UNITED STATES PATENT AND TRADEMARK OFFICE

Office Action Summary

10/566,173

DETAILED ACTION

FIG.1

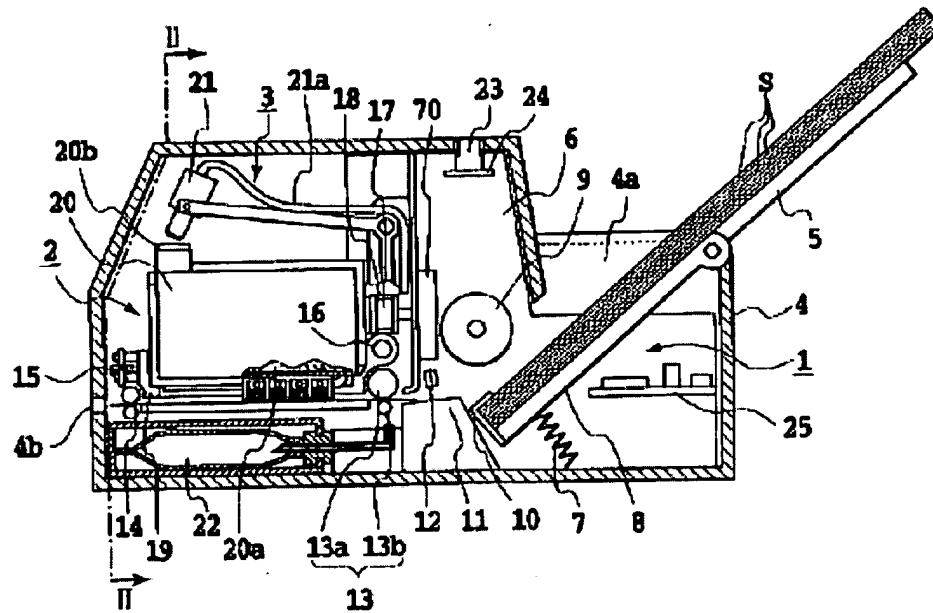
a. As related to independent **claim 1**, Hirano et al. teach an ink container [i.e. supplementary ink tank] (Hirano et al. – Description, Column 15, Paragraph 61 and Figure 1, Reference #22, shown below) connectable and disconnectable to and from an ink supply path [i.e. ink inlet] (Hirano et al. – Description, Column 39, Paragraph 165 and Figure 43, Reference #501A, shown below) including a plurality of ink containing parts [i.e. ink tanks] for containing three or more different inks (Hirano et al. – Description, Column 15, Paragraph 62 and Figure 2, Reference #22Y, #22M, #22C, & #22B, shown below).

FIG. 43

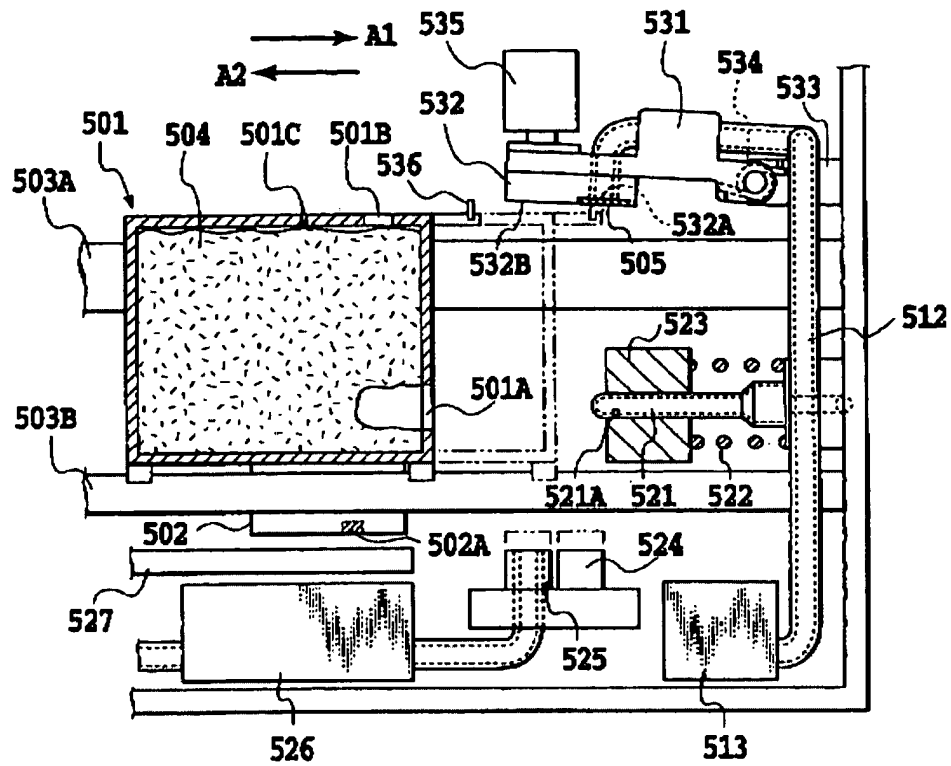
- d. As related to dependent **claim 2**, Hirano et al. teach the plurality of supplying parts can be connected and disconnected to and from a plurality of receiving parts [i.e. ink absorber] in the ink supply path (Hirano et al. – Description, Column 39, Paragraph 165 and Figure 43, Reference #521A & #504, shown previously).

g. As related to further dependent **claim 6**, Hirano et al. teach the connecting section includes a tubular connecting member in communication with the ink containing part, a seal member for sealing an end of the connecting member, and a keep plate [i.e. spring and plate] for securing the seal member at the end of the connecting member; and the

supplying part is located in an opening formed in the keep plate (Hirano et al. – Description, Columns 29-30, Paragraphs 122-124 and Figure 43, Reference #521, #523, #522, & Plate Portion of Connecting Section, shown above).

FIG. 2

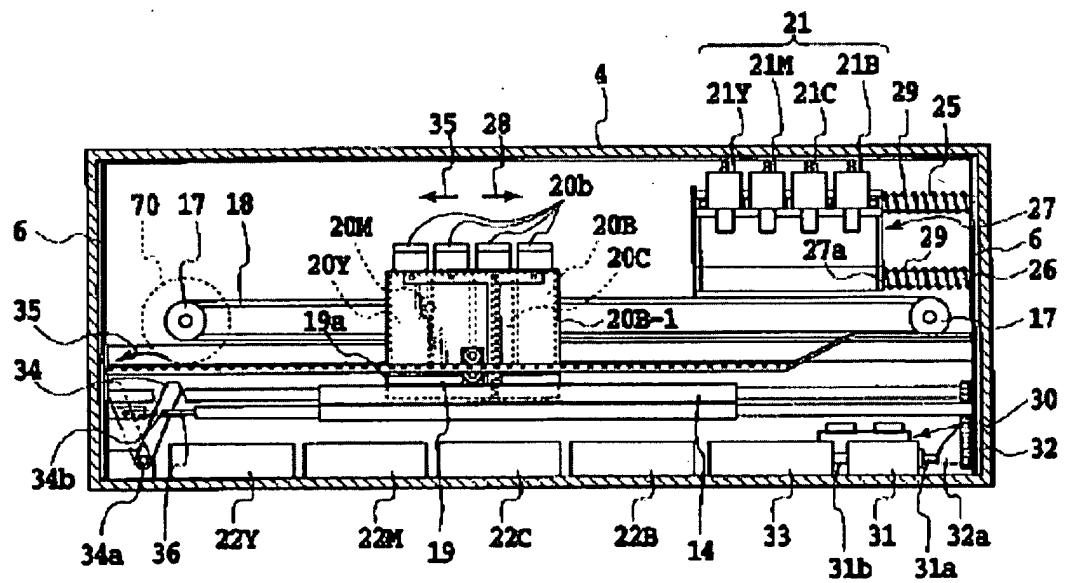
- c. Continuing with **claim 1**, Hirano et al. teach the plurality of supplying parts include a specific supplying part for supplying the ink which undergoes the most significant color change attributable to color mixing of the inks [i.e. Yellow of 501A and 501Y] and the plurality of supplying parts are disposed at respective intervals (Hirano et al. – Figure 44, Reference #521A, #501A, #501Y, & Arrows, shown above). Hirano et al. also teach the interval between the specific supplying part and another of the supplying parts adjacent thereto is greater than the intervals between other supplying parts excluding the specific supplying part (Hirano et al. – Figure 44, Reference #501B & #501Y and interval between as well as #501C & #501M and interval between, shown above). Hirano et al. go on to teach the inks contained in the plurality of ink containing parts include a yellow ink, a cyan ink, and a magenta ink; and the ink which undergoes the most significant color change attributable to color mixing of the inks is the yellow ink (Hirano et al. – Description, Column 15, Paragraph 62 and Figure 2, Reference #22Y, #22M, #22C, & #22B, shown above).

FIG.44

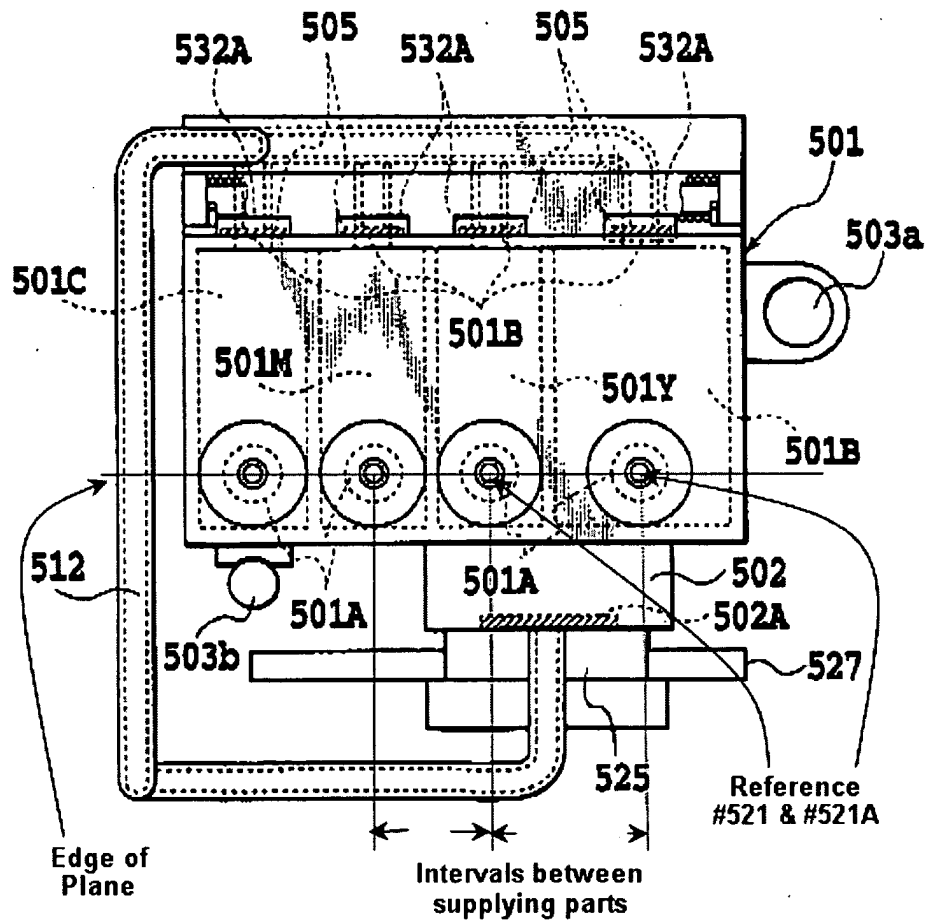
- e. As related to dependent **claim 4**, Hirano et al. teach the plurality of supplying parts are disposed on the same plane (Hirano et al. – Figure 44, Reference #521A and Arrows, shown below).

FIG. 25

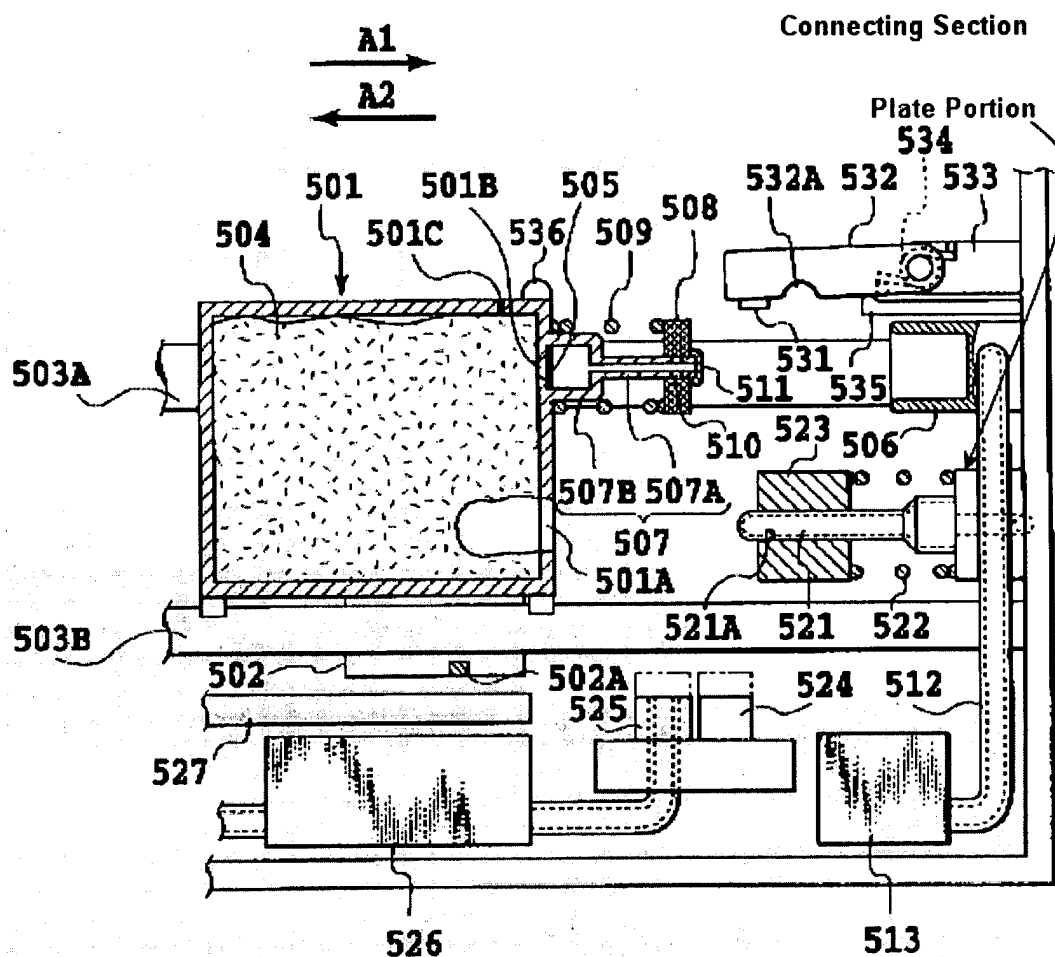
- f. As related to dependent **claim 5**, Hirano et al. teach a connecting section connectable and disconnectable to and from an ink supply path forming member [i.e. wall of sub-tank] in which the ink supply path is formed, wherein the plurality of supplying

parts are disposed at the connecting section (Hirano et al. – Description, Columns 29-30, Paragraphs 122-124 and Figure 43, Reference #532, #536, #501, #501A, #521A, & Connecting Section, shown below)

h: As related to further dependent **claim 7**, Hirano et al. teach the ink supply path forming member is a constituent member of an inkjet printing head (Hirano et al. – Figure 25, Reference #501, #502 & #502A, shown above).

FIG. 7

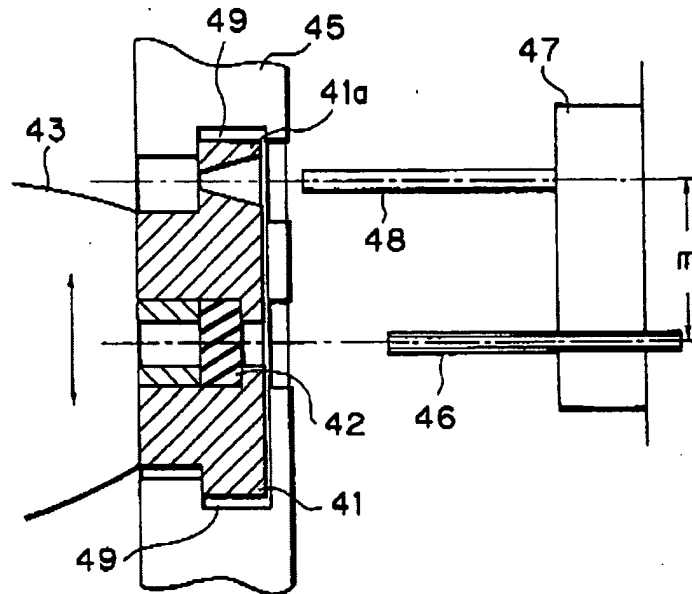
a. As related to dependent **claim 8**, Hirano et al. teach the limitations of **claim 1** for the reasons above and while teaching a possible positioning means [i.e. cap member], *does not* specifically teach the positioning means which positions the ink container relative to the ink supply path forming member. *However*, Hirosawa et al. also teaches an ink container [i.e. ink cartridge container] with a positioning means [i.e. receptacle & gauge pin] which positions the ink container relative to the ink supply path forming member [i.e. ink supply portion] in which the ink supply path is formed (Hirosawa et al. - Detailed Description, Column 5, Lines 23-51 and Figure 7, Reference #45, #47, #41a, #48, & #42, shown below).

c. As related to further dependent **claim 10**, Hirano et al. and Hirosawa et al. teach the limitations of **claim 8** for the reasons above and continue to teach the positioning means includes a hole [i.e. receptacle] which can be engaged with a protrusion [i.e. gauge pin] provided on the ink supply path forming member [i.e. ink supply portion] (Hirosawa et al. – Figure 7, Reference #41a. #48, & #47 shown above.)

FIG.44

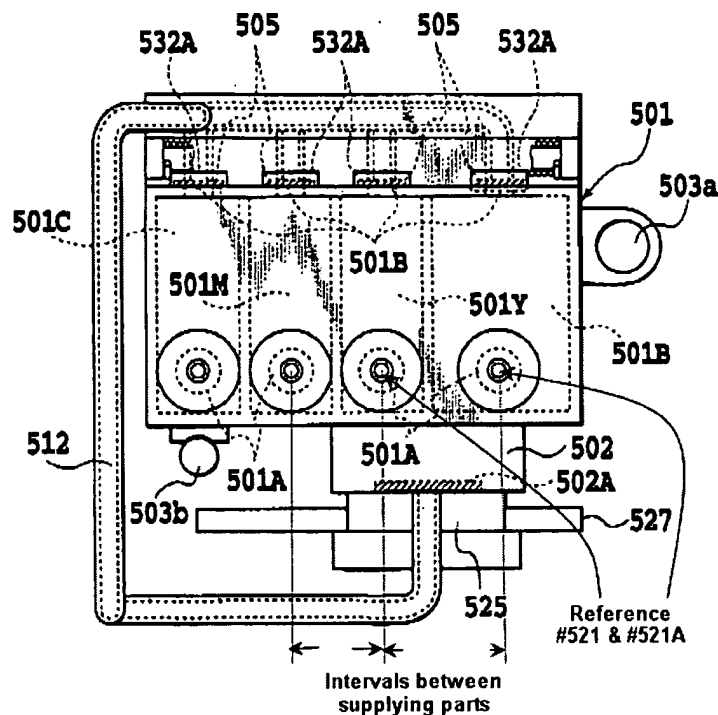
b. As related to further dependent **claim 9**, Hirano et al. and Hirosawa et al. teach the limitations of **claim 8** for the reasons above and continue to teach a plurality of supplying parts adjacent to each other. Given the desire to use the positioning means as such, it would have been obvious to one of ordinary skill in the art at the time of the invention to provide the positioning means at any location adjacent to a supplying part not the least of which would include the specific supplying part, if for no other reason than to use the available space in the wider interval provided between the specific supplying part and the adjacent supplying part (Hirano et al. – Figure 44, Reference #501B & #501Y and interval between as well as #501C & #501M and interval between, shown below).
